\*  
Metropolitan Edison Company (Met-Ed)  
Three Mile Island Nuclear Station Unit 1 (TMI-1)  
Docket No. 50-289  
Operating License No. DPR-50

Technical Specification Change Request No. 36

The Licensee requests that the attached pages replace the corresponding existing Technical Specifications pages.

Figure 2.1-1

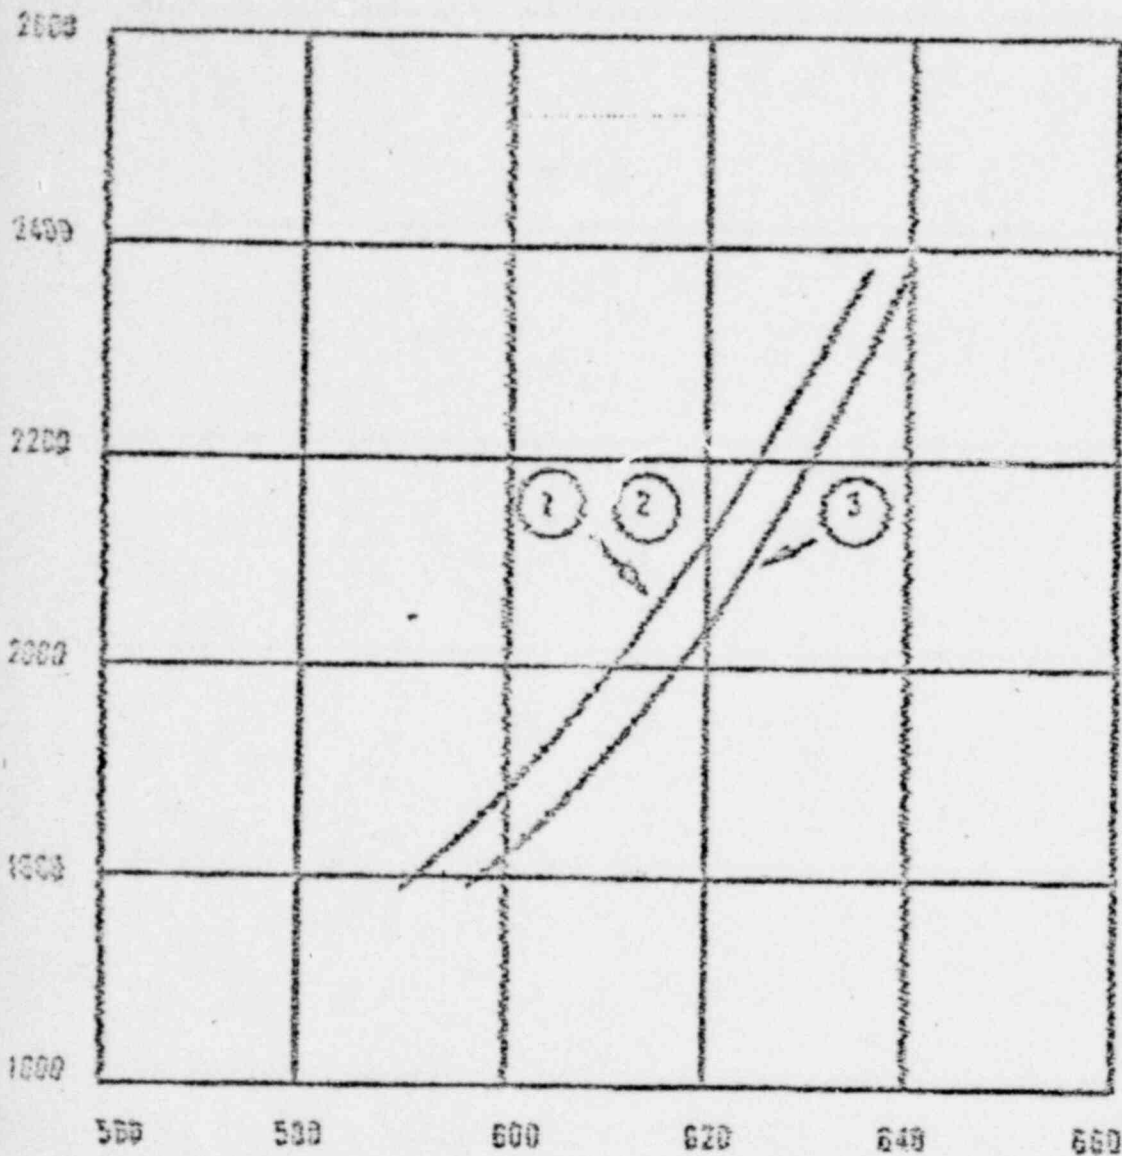
As a prerequisite for eliminating the vent valve flow penalty, the Commission required in its letter of March 10, 1976, "...testing to be conducted each refueling outage to confirm that no vent valve is stuck in an open position and that each valve continues to exhibit complete freedom of movement." This surveillance requirement was performed during the last refueling outage. This proposed change incorporates this surveillance requirement into technical specifications, as well as revised figures 2.1-1, 2.1-3, and 2.3-1 which include credit for elimination of vent valve bypass flow.

Revised densification analysis indicates that the correct penalties are 5.93% DNBR (versus 1.88% in the Reload Report) and 3.47% power peaking relative to DNBR (versus 1.06% quoted in the Reload Report).

The variable low pressure trip setpoint for cycle 2 operation is based on the four pump open vent valve pressure-temperature limit curve presented in figure 8.3 of the Reload Report. The corresponding limit curve, based

on closed vent valves and incorporating the revised densification penalty, will be approximately 3F less restrictive (max. allowable  $T_0$  will be 3F higher at a given pressure).

Verifying vent valve freedom of movement insures that coolant flow does not bypass the core through reactor internals vent valves during operation and therefore insures the conservatism of Core Protection Safety limits as delineated in figures 2.1-1 and 2.1-3, and the flux/flow trip setpoint.
